FIELD REPORT – CARILLON POINT BUILDING 4000 – FIELD REPORT

Report Number: 7

Project No. 10-030608K1

4000 Carillon Point
Kirkland, Washington

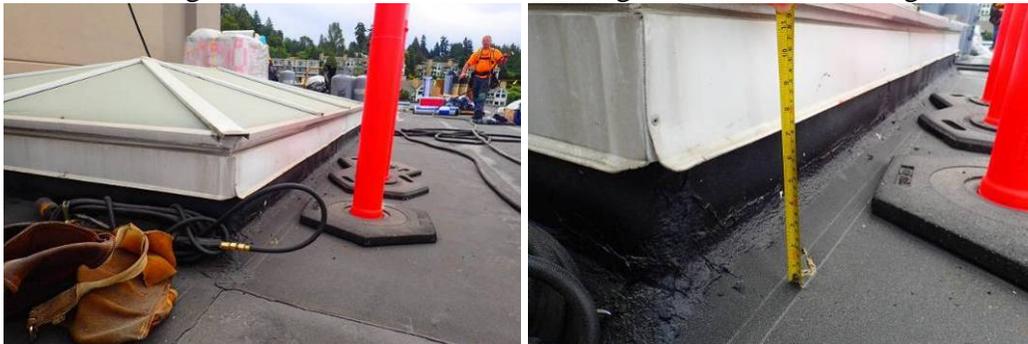
1.6 EIFS on Penthouse Walls: There is existing damage and penetrations to the EIFS on the penthouse walls. A few locations were photographed during the site visit. SR Bldg Services should document all damage prior to work. It is suggested that Carillon Properties repair damaged areas, and areas with penetrations, to help prevent water infiltration.

Roof Plan:

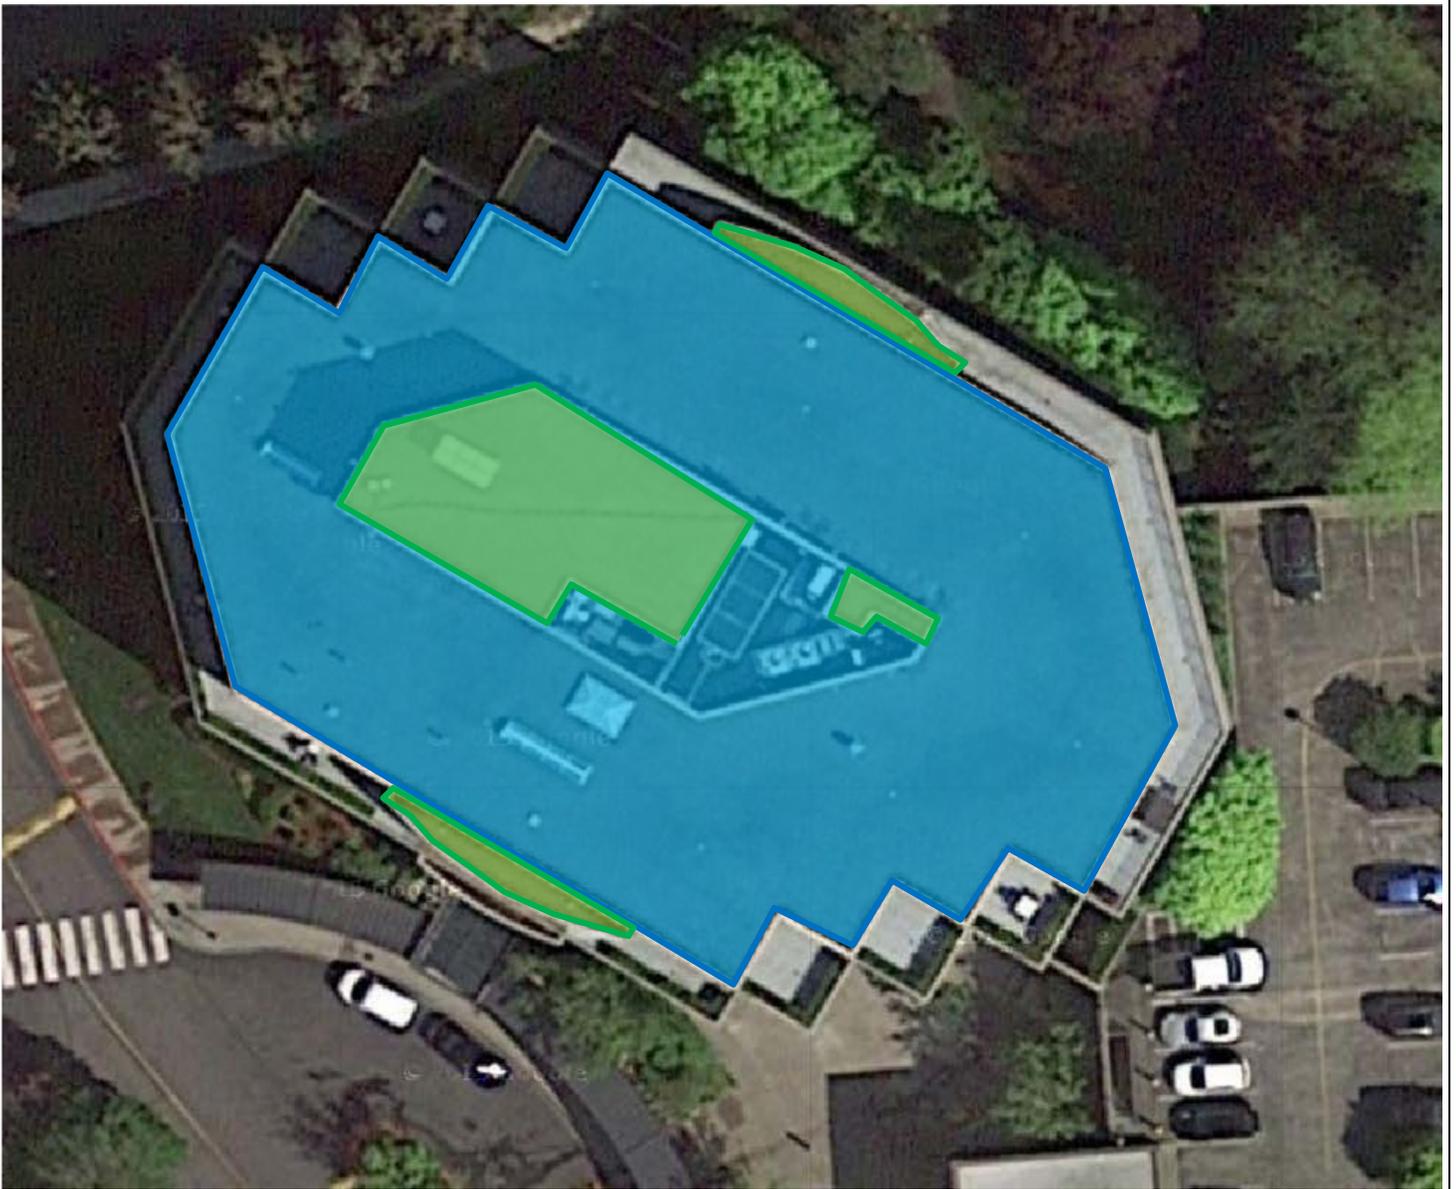
Location of roof assembly installed through capsheet

Location of roof assembly installed through interply
